ADDENDUM NO. 1 TO PROJECT NO. Q1847

CONSTRUCTION WORK REPLACE ROOF DOT REGION 8, WESTCHESTER COUNTY 1 DANA RD VALHALLA, NY 10595

March 14, 2025

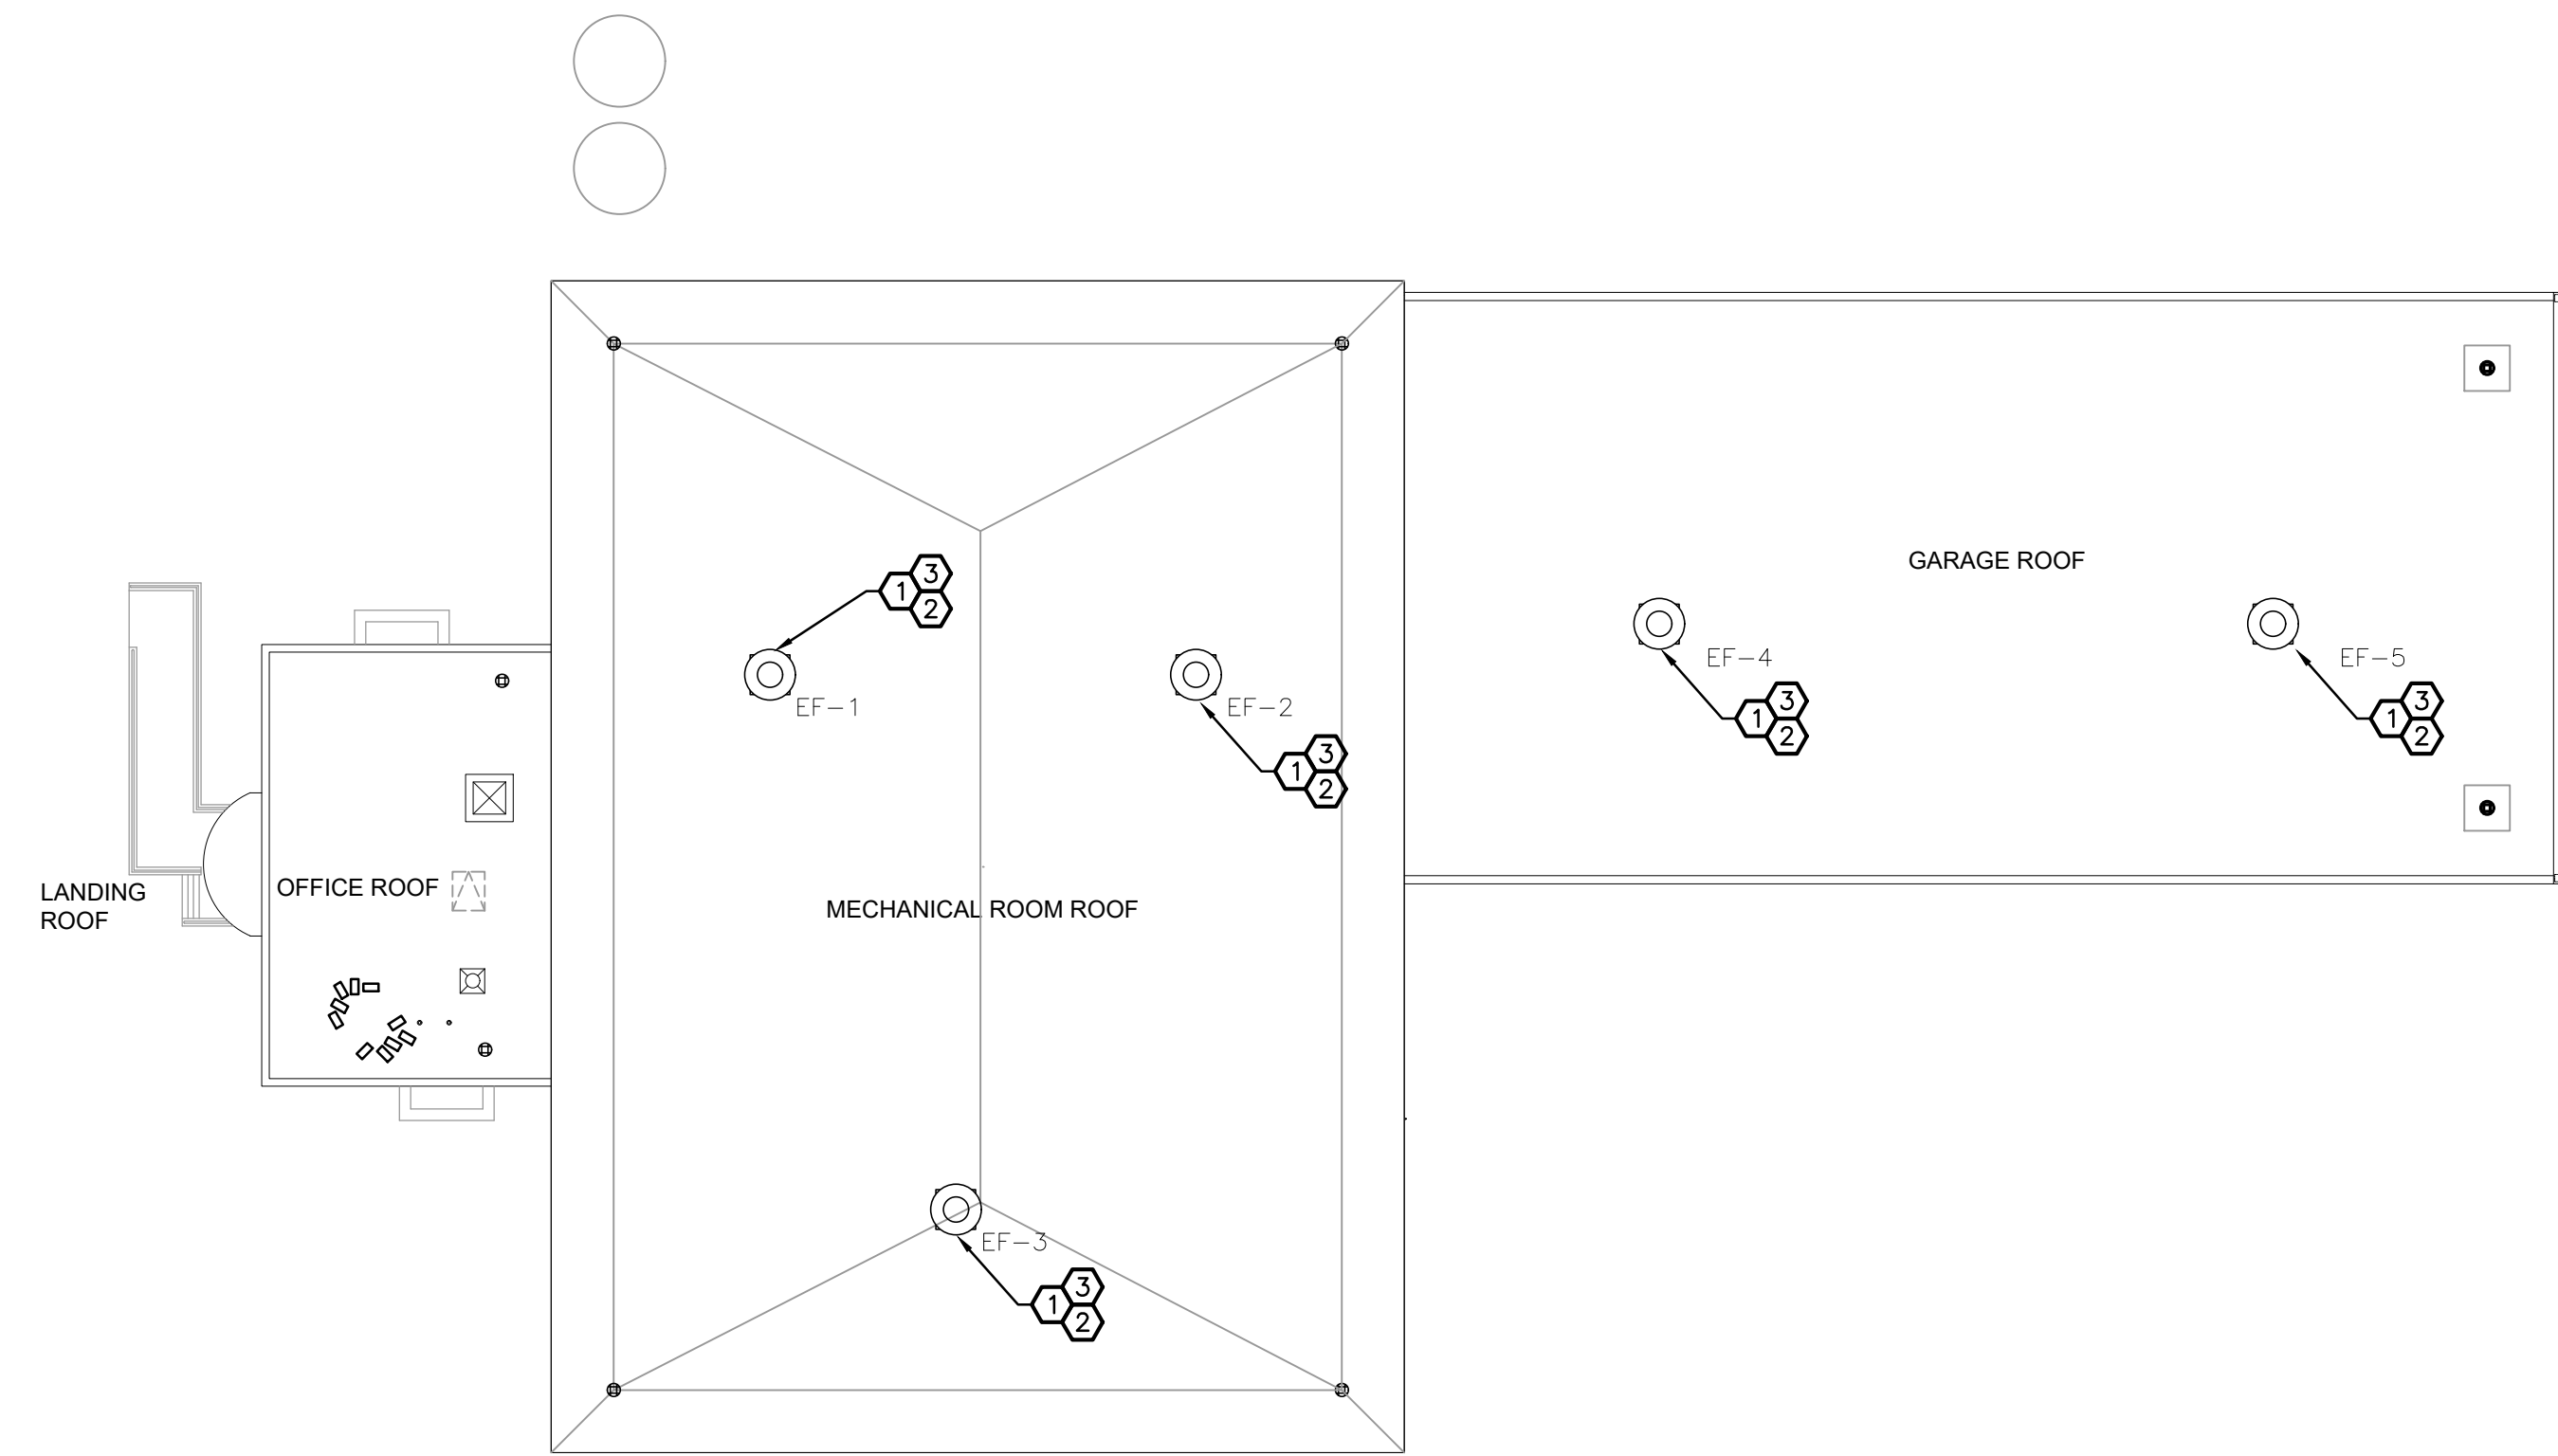
2. Drawing No. A-001:
 - a. CONSTRUCTION SAFEGUARDS, Add the following Note:
 - “5. Provide ~8’ wide x 22’ long Overhead Protection at each Garage Door during all stages of work, typical of ten (10). Overhead protection shall be similar to the ~8’x10’ and ~17’x35’ shown on drawing (A-101). Sidewalk sheds shall not impede the passage of vehicles, equipment or pedestrians.”
3. Revised Drawing:
 - a. Drawing No. ME-101, noted as “PRE-BID ADD #1 3/13/2025”, accompanies this addendum and supersedes the same numbered originally issued drawing.
